Access Compliance Report

Public Rights-of-Way

Intersection ID: 13143	Main Street: OSMOND_ST	Cross Street: BETHEL_RD	Location: SE
ADA ID: E5A3BA4BC0BF	Ramp Type: BlendTrans1	Initial Pass/Fail: Fail	Overall Compliance: No
			Severity Score: 18.75

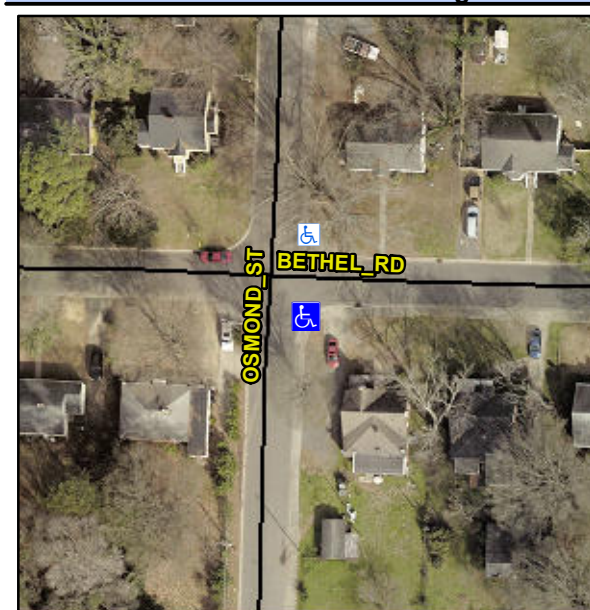
Not Found, R304.5.1, R304.5.3

Compliance	Description	Data	Compliance	Description	Data
N/A	Ramp Length (in)	59.0	Yes	BlendTrans Slope (%)	2.5
No	Ramp Width (in)	34.5	No	BlendTrans XSlope (%)	4.4
N/A	Flare Type LT	N/A	N/A	Flare Type RT	N/A
N/A	Flare Slope LT (%)	N/A	N/A	Flare Slope RT (%)	N/A
N/A	Flare Traversable LT?	N/A	N/A	Flare Traversable RT?	N/A
N/A	Landing Length (in)	N/A	N/A	DWS Provided?	N/A
N/A	Landing Width (in)	N/A	N/A	DWS Contrast?	N/A
N/A	Landing Slope (%)	N/A	N/A	DWS Length (in)	N/A
N/A	Landing X Slope (%)	N/A	N/A	DWS Full Width?	N/A
N/A	Landing Curb? (Y/N)	N/A	N/A	DWS Offset (in)	N/A
N/A	Shared Landing?	N/A			
N/A	Gutter Ponding?	N/A	N/A	Gutter Slope (%)	N/A
N/A	Gutter Lip Ht (in)	N/A	N/A	Gutter X Slope (%)	N/A
N/A	Painted X Walk1?	No	N/A	Painted X Walk2?	No
	X Walk 1 Direction	To N		X Walk 2 Direction	To W
	X Walk 1 Width (in)	N/A		X Walk 2 Width (in)	N/A
	X Walk 1 Slope (%)	4.7		X Walk 2 Slope (%)	2.6
	X Walk 1 X Slope (%)	0.6		X Walk 2 X Slope (%)	4.0

N/A	Ramp inside XWalk1?	N/A	N/A	Ramp inside XWalk2?	N/A
	Road Slope (%)	2.4		Clear Space?	N/A
	Road X Slope (%)	3.0	N/A	Clear Space to XWalk (in)	N/A
N/A	Any Obstructions?	N/A	N/A	Storm Grate/Utility Hazard?	N/A
	Obstruction Type			Storm Grate/Utility Type	
		N/A			N/A
			Yes	Surface Condition? (G/P)	Good
			No	Curb Slope (%)	16.3

Remove & Replace Curb Ramp With Two New Directional Ramps or Equivalent.
